HYUNDAI

Technical Service Bulletin

GROUP	NUMBER
ENGINE MECHANICAL	26-EM-003H
DATE	MODEL(S)
FEBRUARY 2026	SONATA (DN8/DN8A)

SUBJECT: INTEGRATED THERMAL MANAGEMENT (ITM) REPLACEMENT & ECM/TCU SOFTWARE UPDATE – DTCS P218100, P2181F0, P2181F1

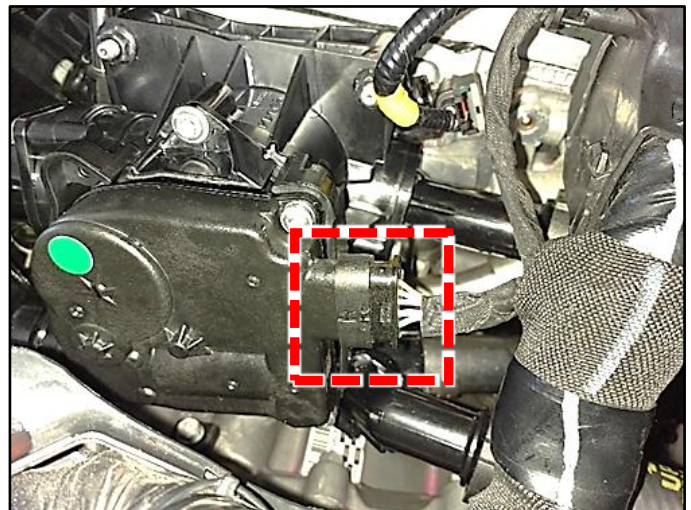
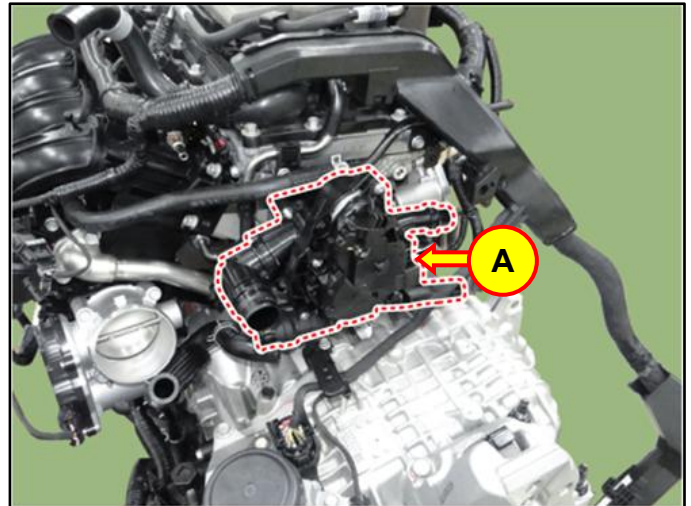
2. Replace the ITM (A) by referring to the shop manual.
 - **Engine Mechanical System > Cooling System > Integrated Thermal Management Module (ITM) > Repair procedures**
3. Reinstall parts in the reverse order of the removal process.

The ITM design inverts the connector's orientation.
